May 23, 2008
E-26486

Subject: Revision 3 to Transnuclear, Inc. (TN) Application for Amendment 10 to the Standardized NUHOMS® System (Docket No. 72-1004; TAC NO. L24052)

Reference: Letter from B. Jennifer Davis (NRC) to Donis Shaw (TN), "SECOND REQUEST FOR ADDITIONAL INFORMATION FOR REVIEW OF AMENDMENT 10 TO THE STANDARDIZED NUHOMS® SYSTEM (TAC NO. L24052), INCLUDING UPDATED REVIEW SCHEDULE," April 23, 2008

Figure 3-1-1: Comparison between the Irradiated and Unirradiated Materials (Tensile Strength and Displacement as a Function of Hydrogen Concentration)
(From Figure 8-b of Reference 3-1-2)

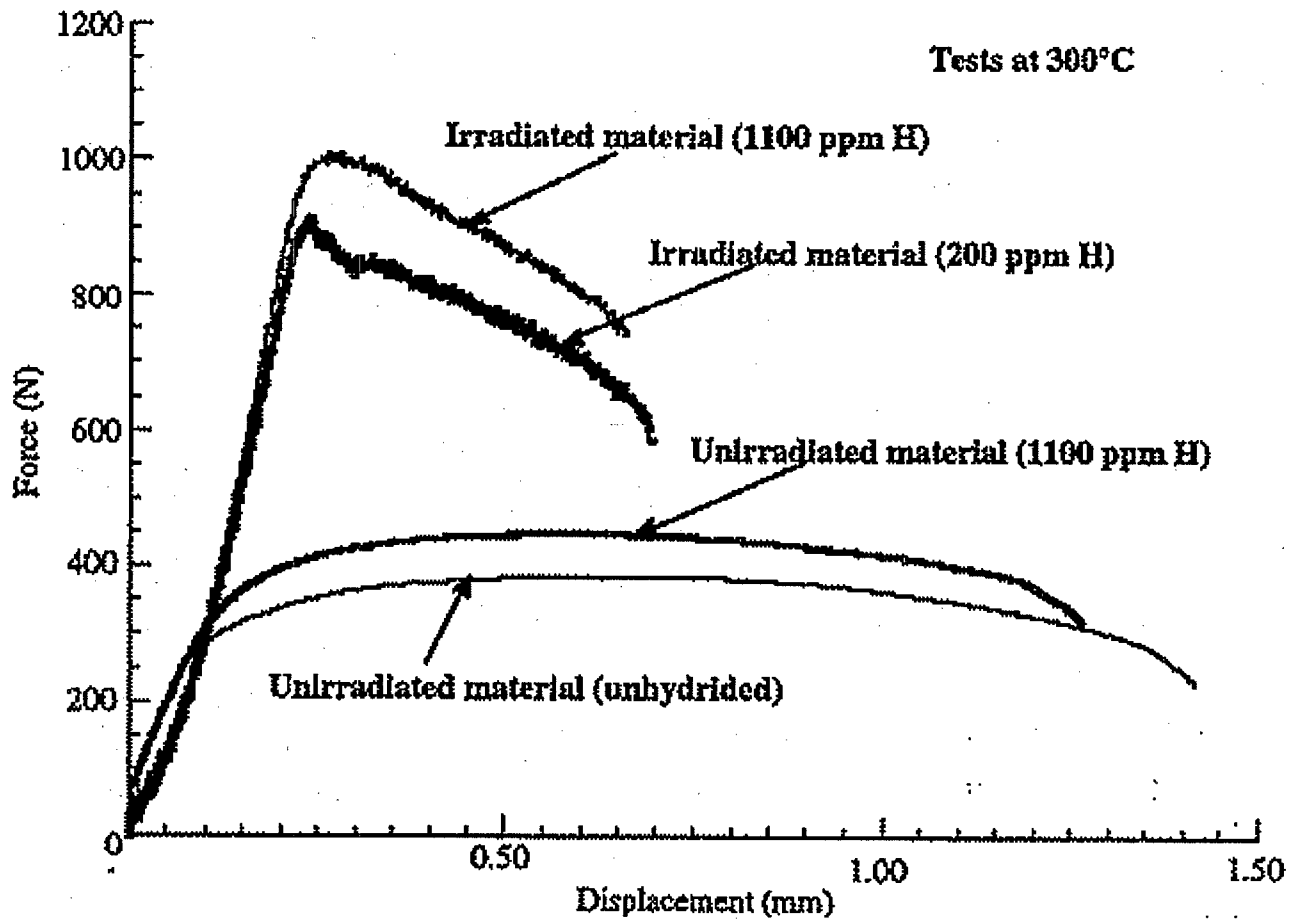
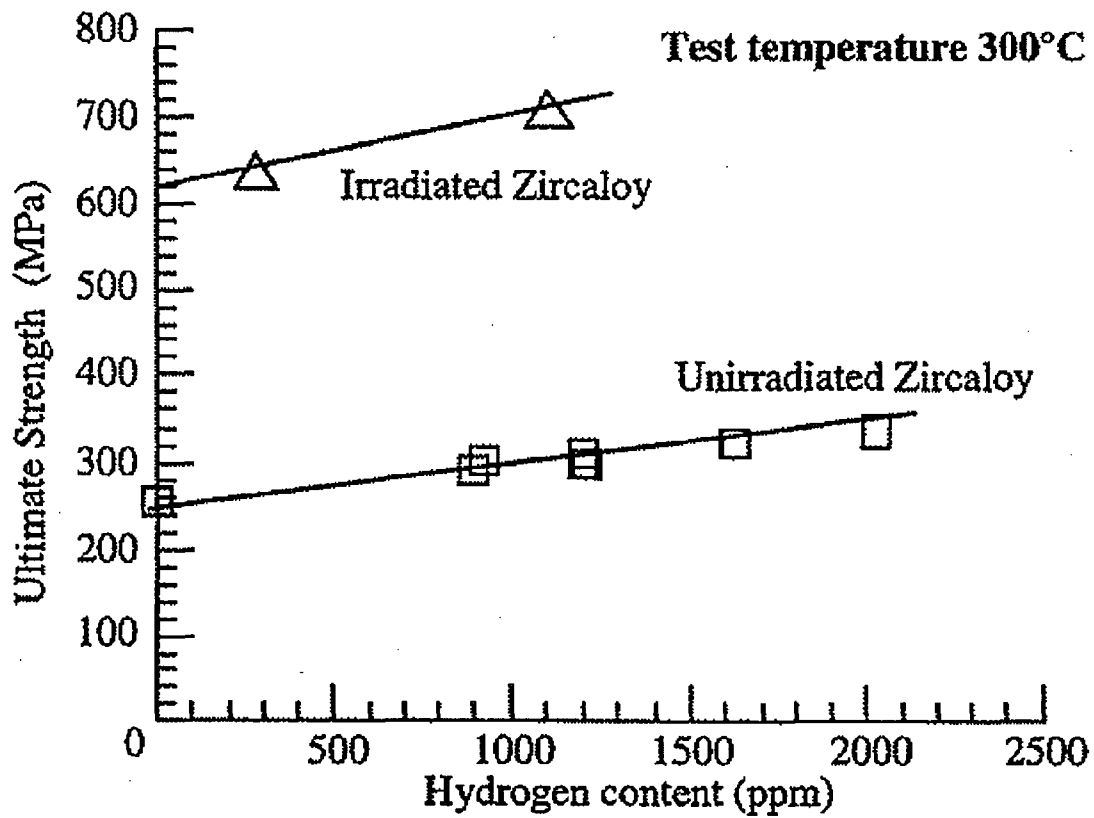
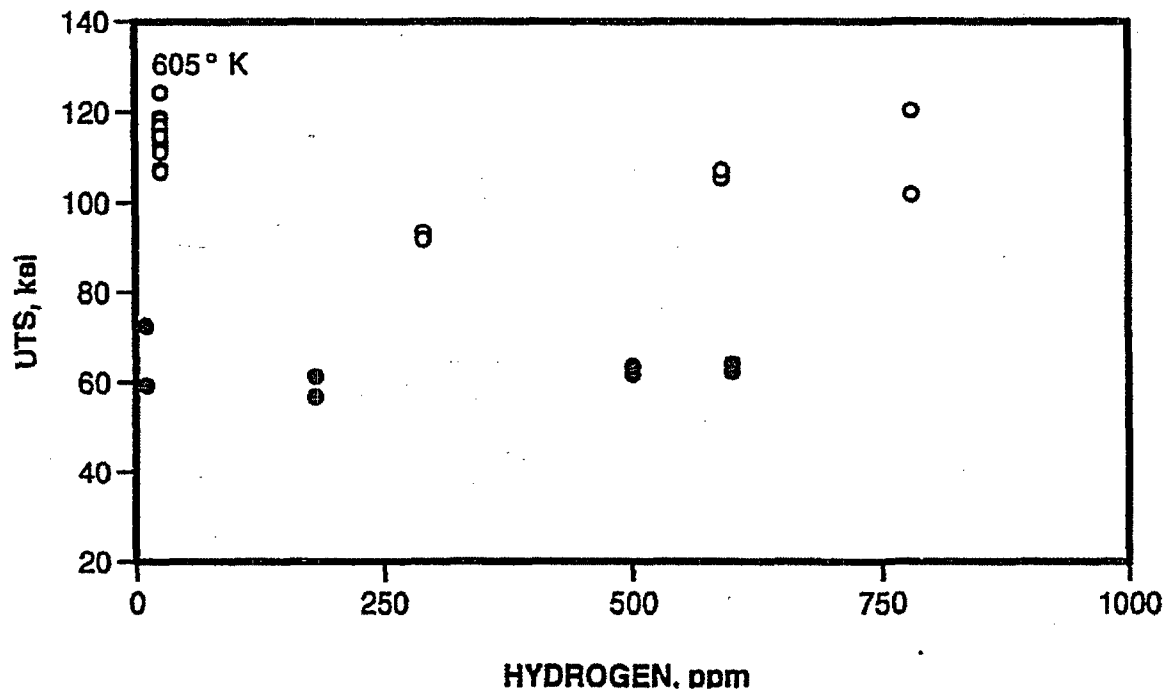
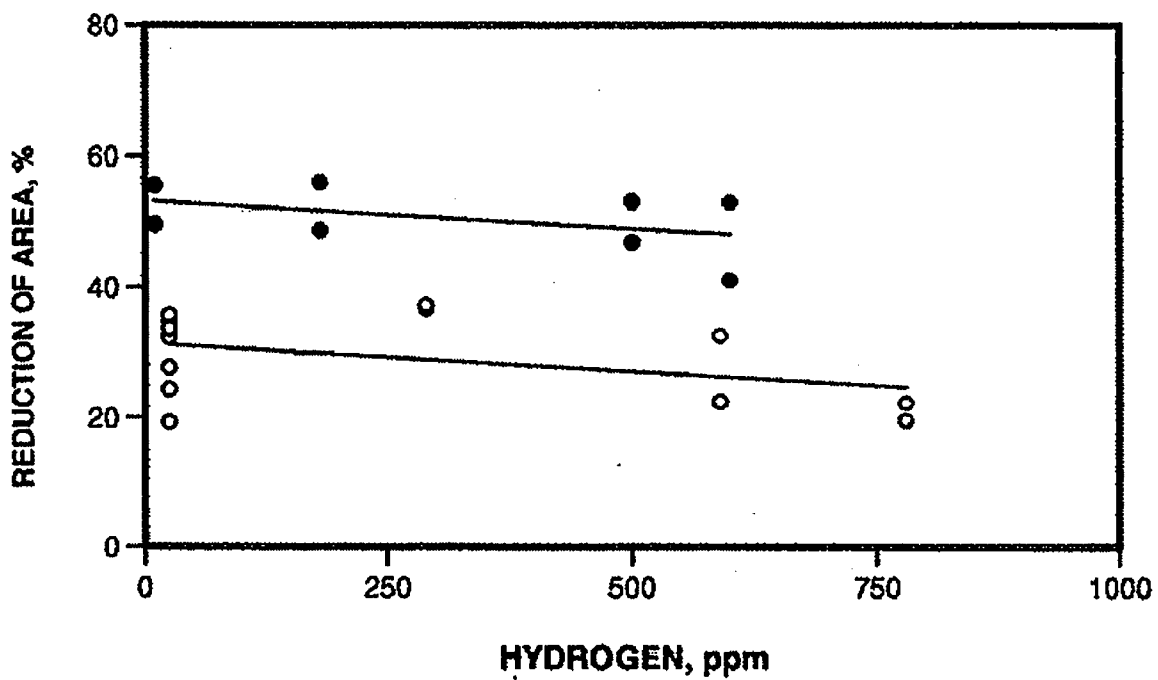
3-1: *With respect to your response to RAI 3-4 (Round 1), please provide justification for the assumption that the mechanical properties of unirradiated Zircaloy with radial hydrides represent the behavior of high burn-up irradiated Zircaloy-2 with radial hydrides.*

In addition, it is also important to point out that based on the results shown on the response to RAI # 1, Question 3-4 [3-1-4] the maximum calculated hoop stress is 24,312 psi. This calculated stress, when compared with the reduced cladding yield strength (20% reduction), still shows a factor of safety of 2.43. The uncertainty of the yield strength of the cladding due to the effect of radial hydrides can be easily accommodated with this large margin of safety.

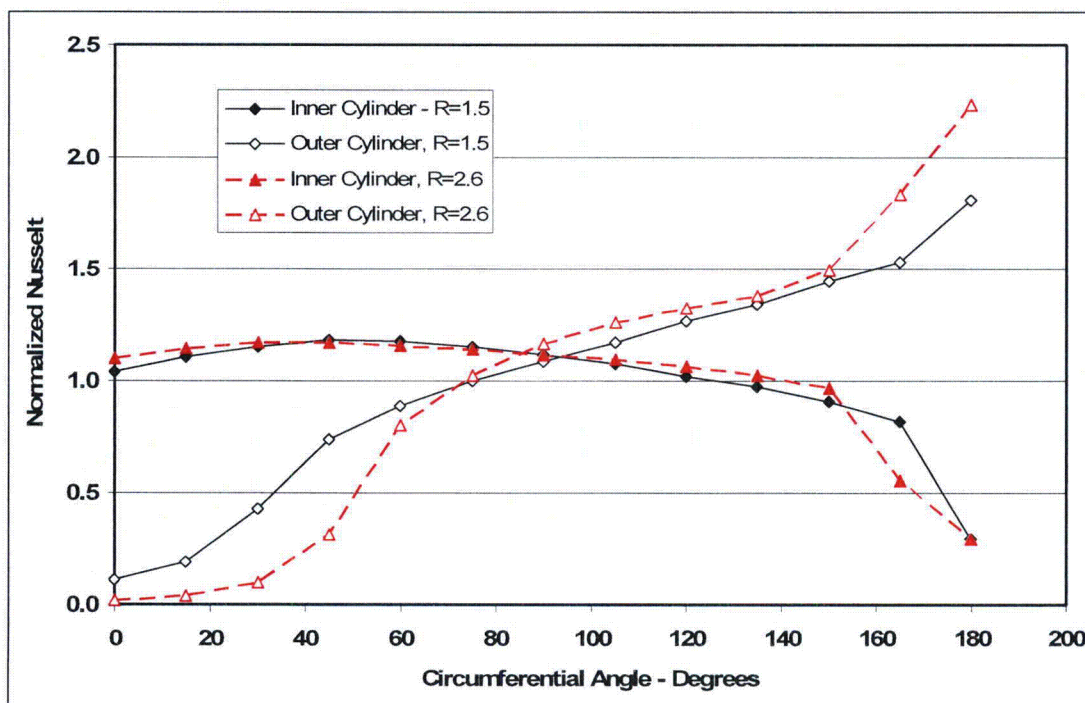
- 4-5:** *Provide a discussion of how a circumferentially varying Nusselt number in the liquid neutron shield annulus would effect the temperature distribution of the DSC within the OS-200 TC. Include a discussion of the effects of the stagnation zone at the bottom of the liquid neutron shield annulus. A discussion of the limitations associated with the constant Nusselt number approach, as presented in Section U.4.5.2 and U.4.2 of the SAR, should also be included.*

Based on these trend lines, it is concluded that the trend lines in Figure 14 can be used to estimate the variation in the Nusselt number with angle for this application. For conservatism, the trend lines for $R=2.6$ are used to conservatively bound the gradient in heat transfer rates on the outer cylinder. The data points in the figure above are used to convert the average k -effective values presented in Table 4-14 of the NUHOMS[®] HD FSAR to local values as a function of angle and position in the neutron shield. Since the thermal modeling for the OS200 TC neutron shield sub-divides the shield into 3 elements in the radial direction and at every 15° around the circumference, the approach is to use the variation along the inner cylinder (i.e., the structural shell of the TC) vs. the angle for the inside set of elements, the variation along the outer cylinder (i.e., the shell of the neutron shield) for the outside set of elements, and the average of the two for the center set of elements used in modeling the shield. The effect is to vary the k -eff from approximately 112% of the average at the bottom, inside of the neutron shield to approximately 43% of the average at the top, inside of the shield and from approximately 203% of the average at the top, outside of the shield to 4% of the average (i.e., pure conduction/stagnation) at the bottom, outside of the shield.

Figure U.4-11
HSM-H Component Temperature Distributions for
Blocked Vents Accident Storage Condition @ 35 hr, DSC with 40.8 kW, 117°F Ambient

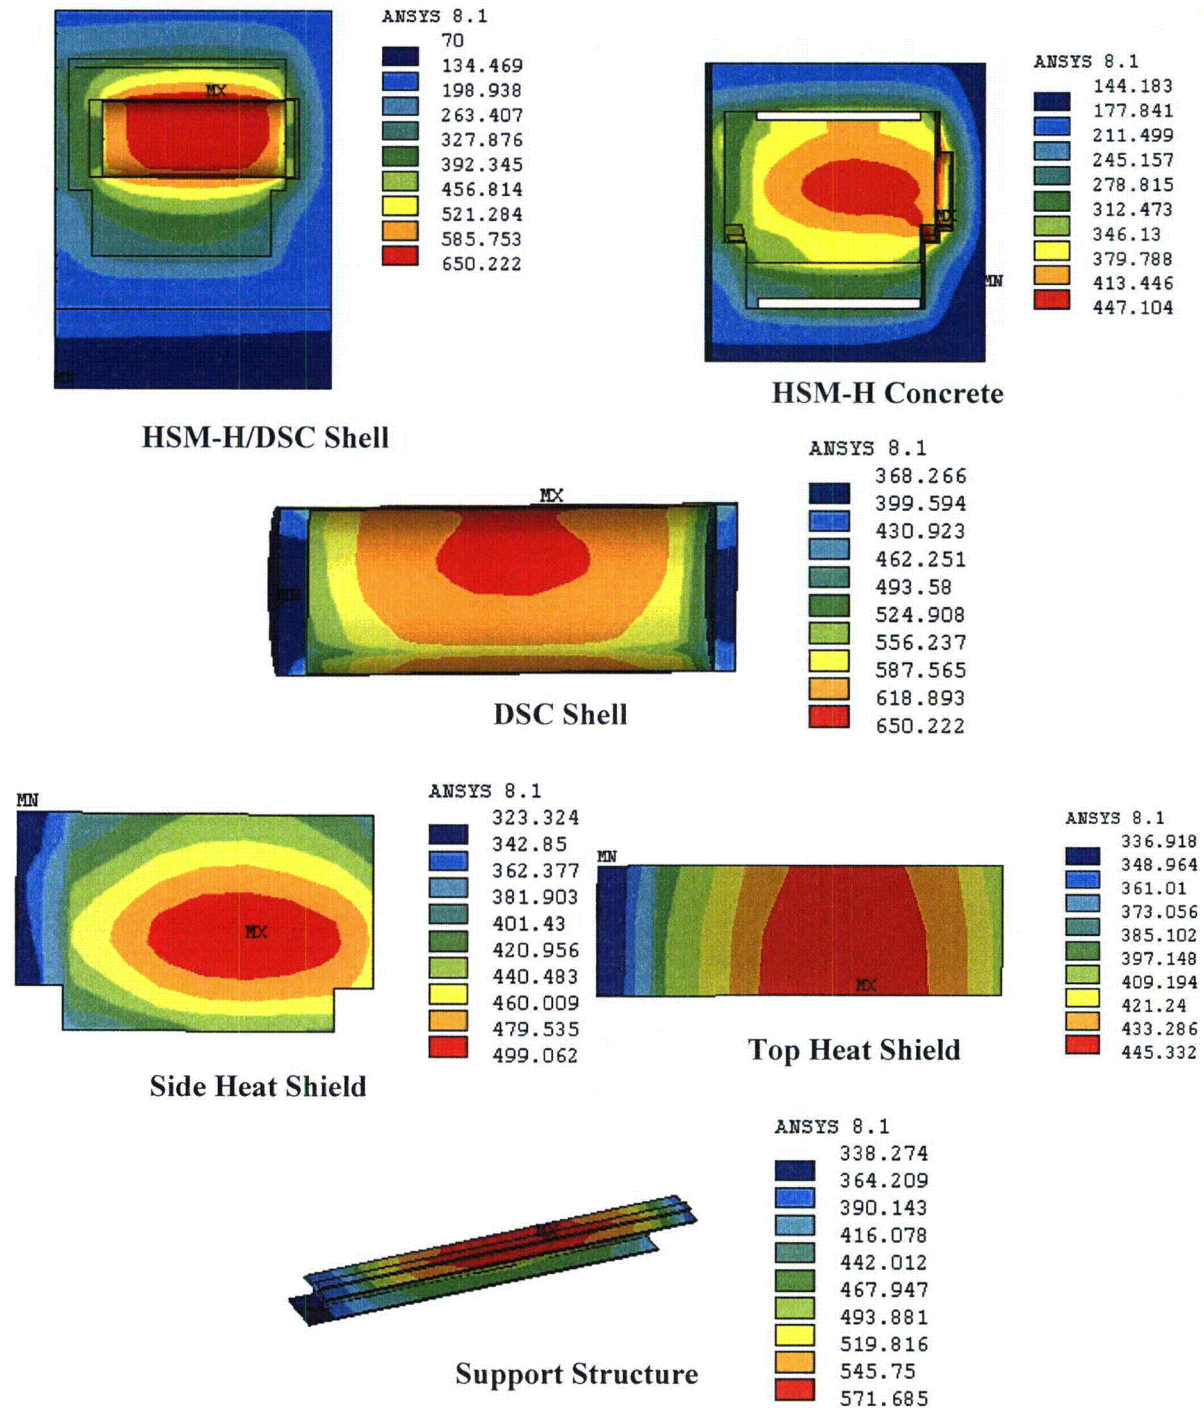
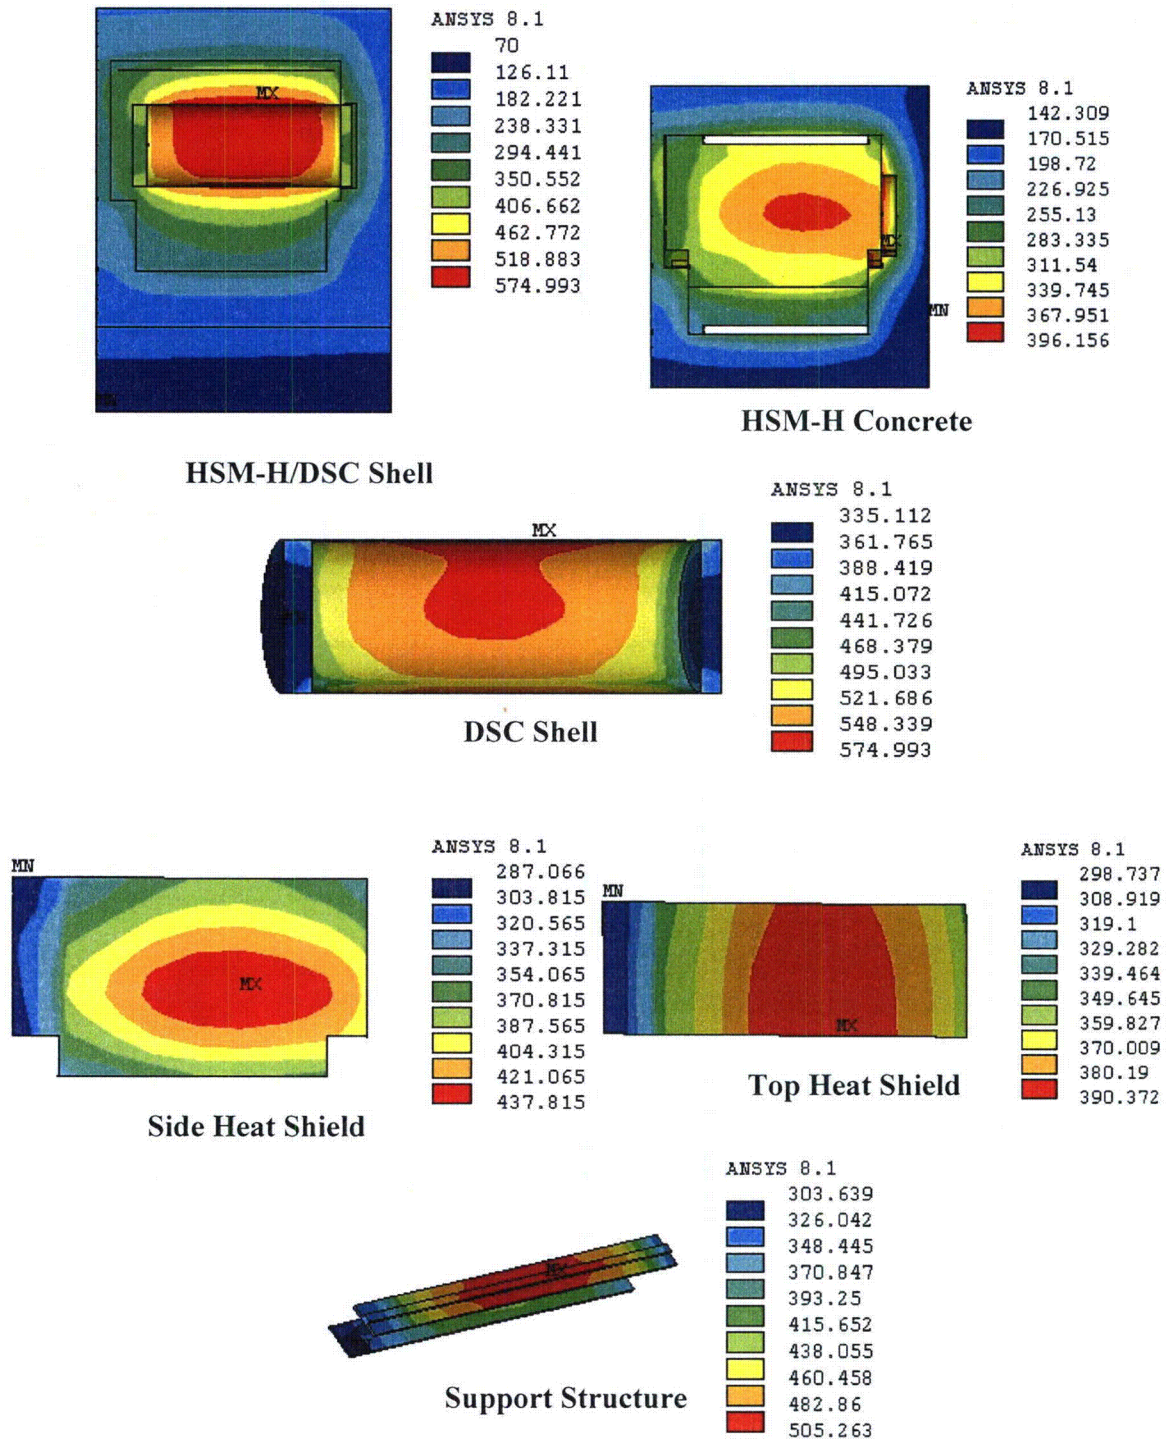
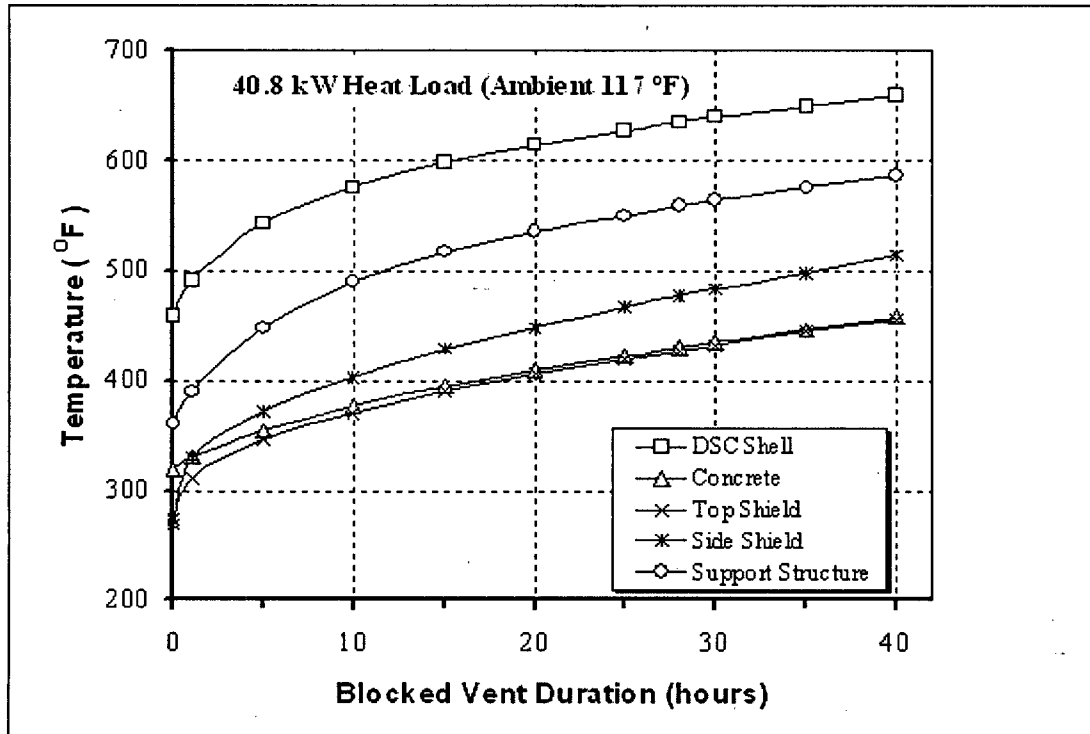
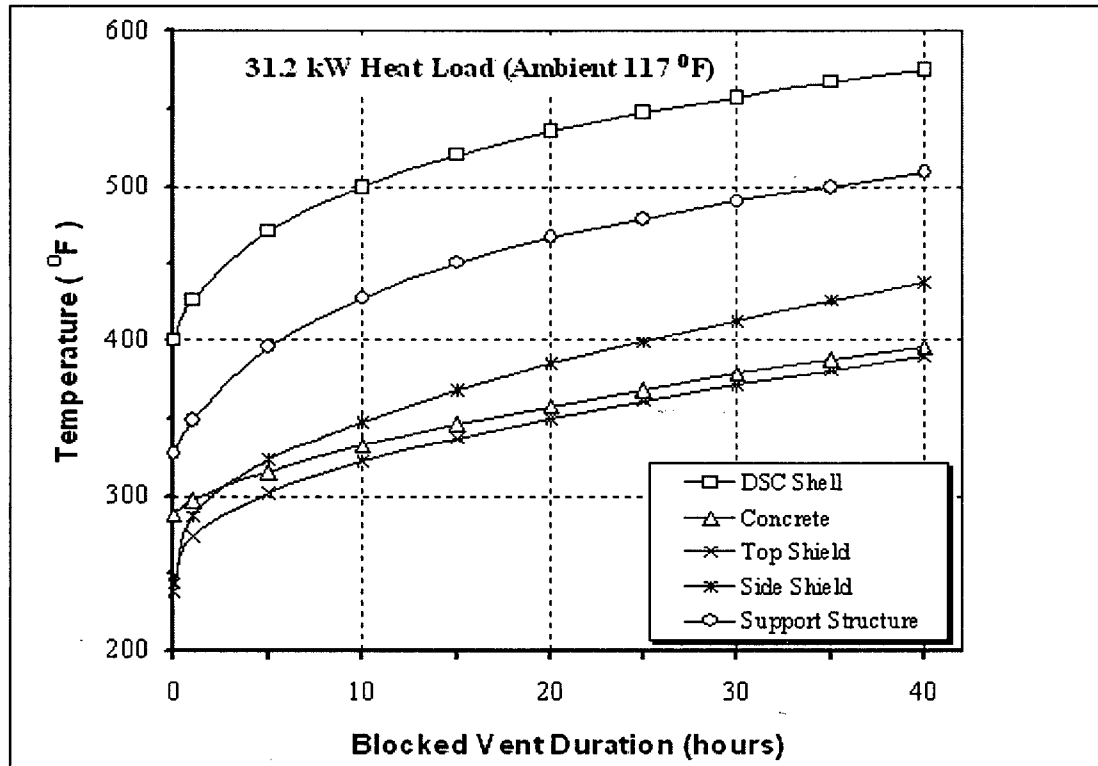
- 4-12:** *Clarify the phrase: "7.9° No Convection Zone," which appears in Figures U.4-11 and U.4-13 for the Blocked Vent accident condition transient.*

Captions for Figures U.4-11 thru U.4-13 include the added phrase "7.9° No Convection Zone." Given that the blocked vents accident neglects convection (i.e., conduction only to cavity air) within HSM-H, according to SAR text (see Section U.4.4.5 – Description of

The NRC staff observation is correct. The HSM-H Model for the blocked vent accident condition assumes no convection within the HSM-H cavity.

The evaluations in Amendment 10 SAR, Rev. 1 account for a "dead zone" of 18.9° for the normal and off-normal analyses of an HSM-H with a 32PTH1 DSC. Since the initial conditions for the blocked vent transient analysis are based on off-normal conditions, the maximum temperatures for the blocked vent accident conditions were also affected by increasing the dead zone angle to 18.9°. This change resulted in corrections in Rev. 1 of Table U.4-3, Table U.4-24 through Table U.4-26, and Figure U.4-10. Since the temperature distributions for HSM-H components except for the DSC shell are similar before and after the correction of the dead zone angle, the temperature distributions and the time histories in Figure U.4-11 through Figure U.4-14 do not include new information and are not updated. The intention of the phrase "7.9° No Convection Zone" is to indicate that the content of the corresponding figures is not updated. This phrase is revised in Revision 3 of Amendment 10 to clarify the intention.
